REVIEW TYPE: Site Plan Review (Amendment)

APPLYING FOR: Plaza design upgrade, addition of 1500 gsf retail

PROJECT NAME: Bethesda Metro Center

CASE #: 8-88045B

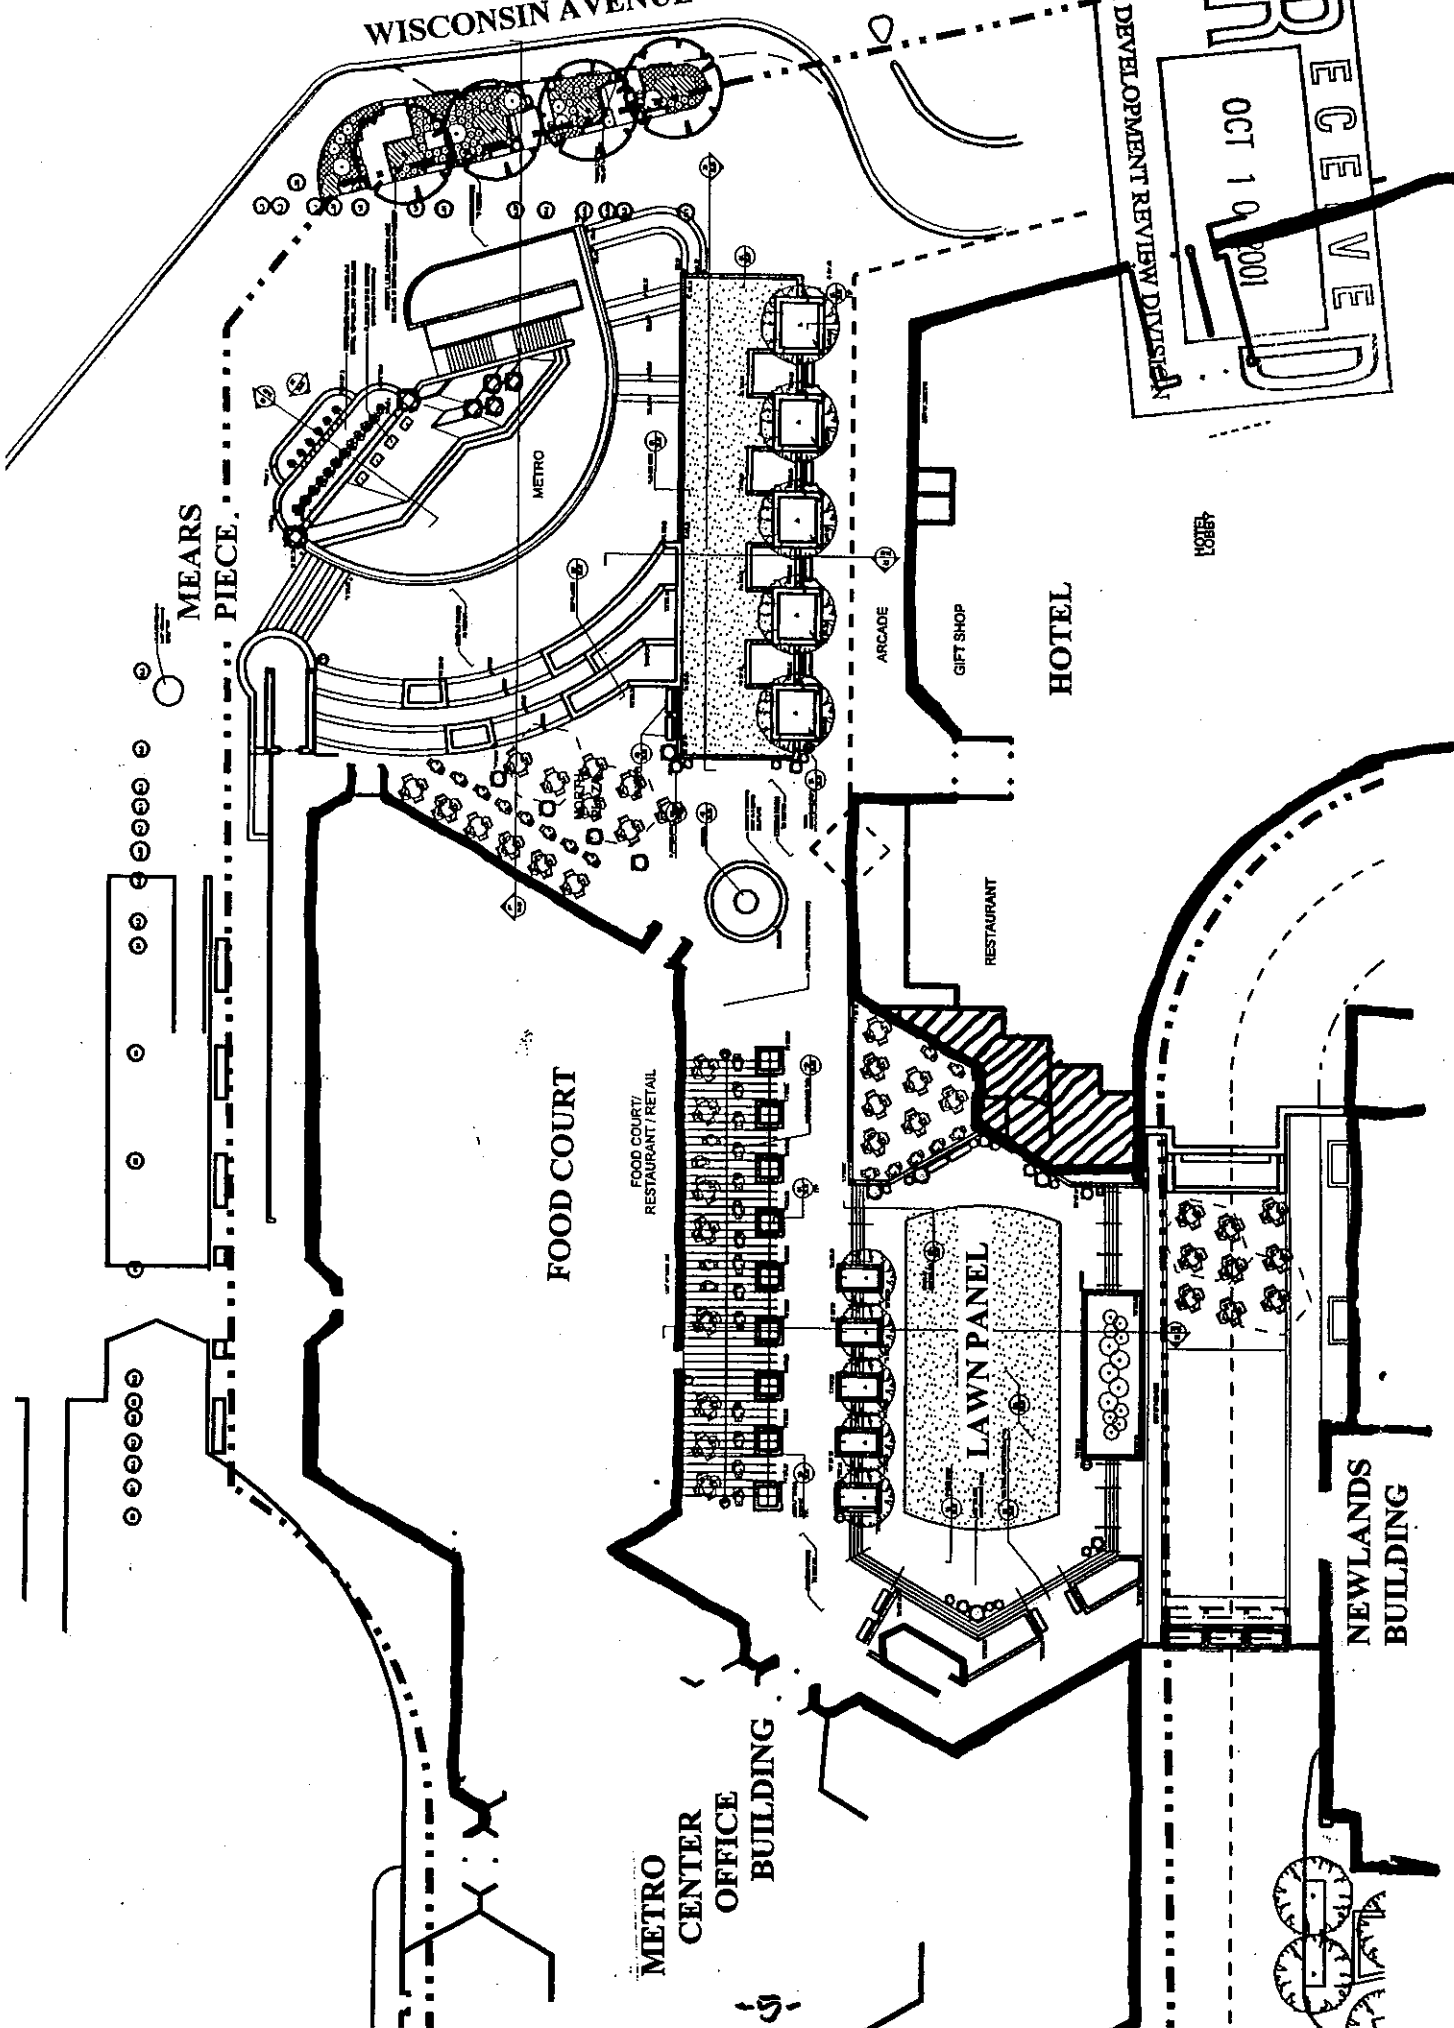
2. Applicant agrees to perform any maintenance on the Mary Ann Mears sculpture which is deemed necessary by Ms. Mears.
3. The proposed modification of the curb at the corner of Old Georgetown Road and Wisconsin to create a dropoff lane just north of the hotel porte-cochere is specifically denied.

5. Move proposed Mears piece approx. 20' ESE, to be visible from plaza
